**RE: 425 FIRST STREET**

I reviewed the drawings and evaluated the site context. My comments and suggestions are as follows:

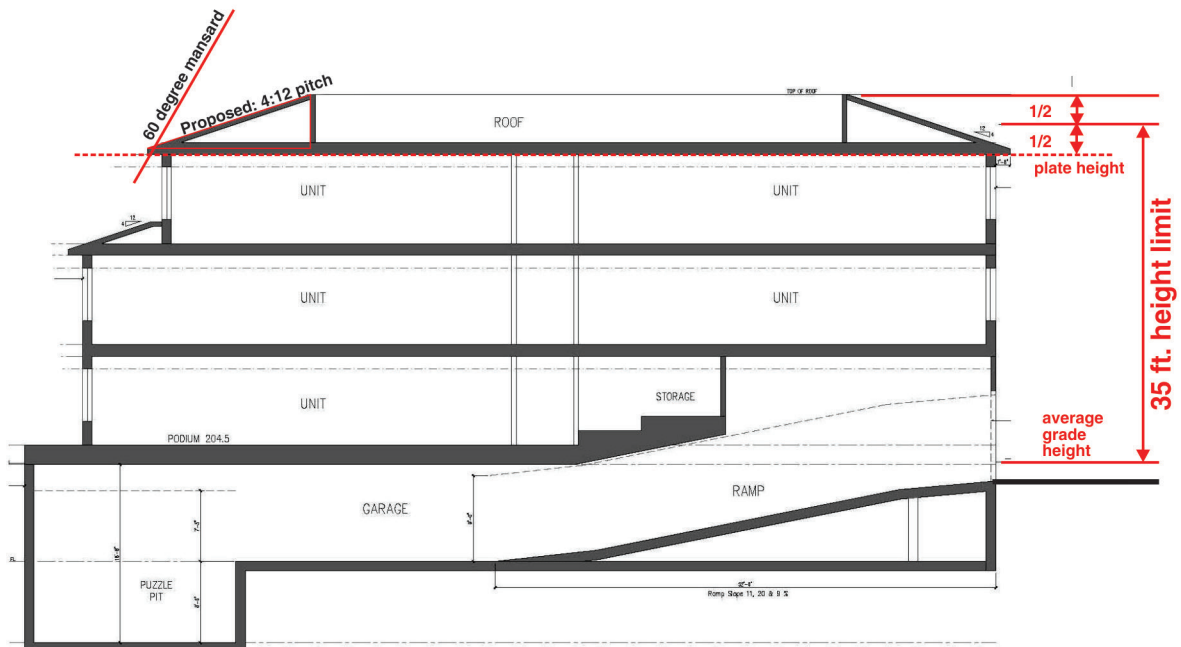
1. The two-foot setback on Lyell Street may not be consistent with Downtown Design Guideline 5.1.7.

When the design guidelines were developed, primary attention was given to the urban design characteristics of the major streets and pedestrian routes in the downtown area. Less focus was placed on secondary streets. Staff and the Planning Commission will need to assess whether a greater setback on Lyell Street is warranted.

**Roof pitches are shallow for this traditional architectural style**

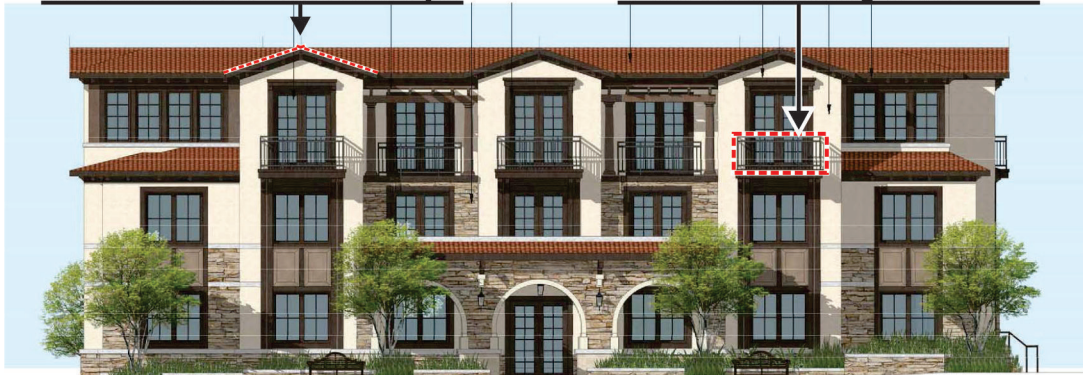
- The roof pitches of 4:12 are shallow for this architectural style, and less than the more typical 6:12 pitch, as utilized on the similar multifamily project immediately across First Street.

**Metal railing is plain compared to the other building details**

4. Wood balcony railings are more common for this architectural style, but metal railings are also common and acceptable. The only concern here is that perhaps an opportunity is being missed to provide a richer design to the railings which is also common for the architectural style - examples are shown in the recommendations.
5. The exit stair on Lyell Street will be rather prominent. Some refinements might be considered to enhance the architectural style and pedestrian experience.

**Recess doors and match materials and colors to window panels above**

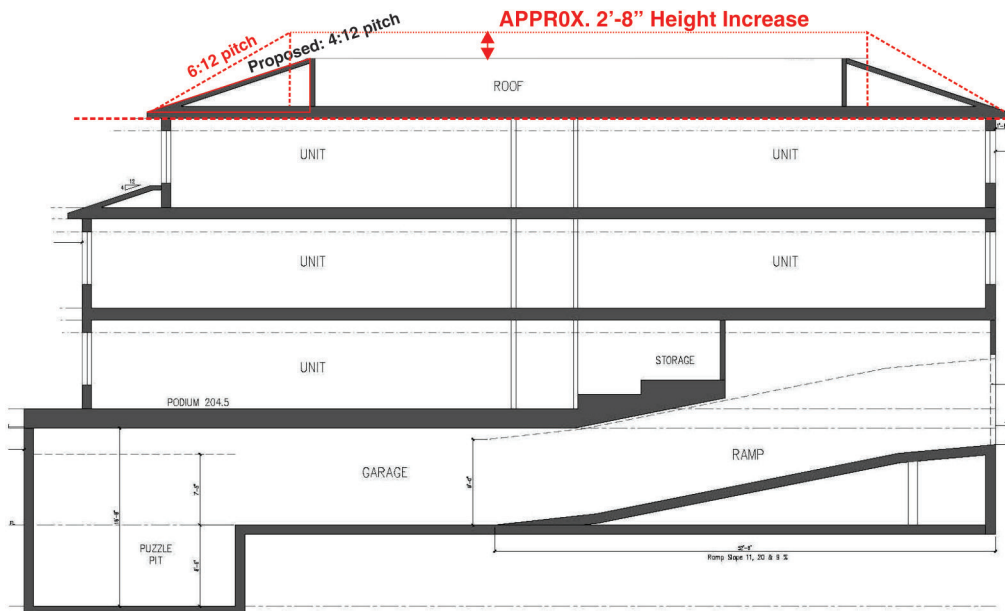
6. The visual exposure of the rear alley elevation will be as great as the street elevations. Currently the garage and stair exit doors on the rear elevation are much more utilitarian in appearance than the rest of the facade.

**Doors seem under developed compared to rest of building**

3. Recess the garage and exit stair doors on the rear facade, and match materials and colors to the window panels above.
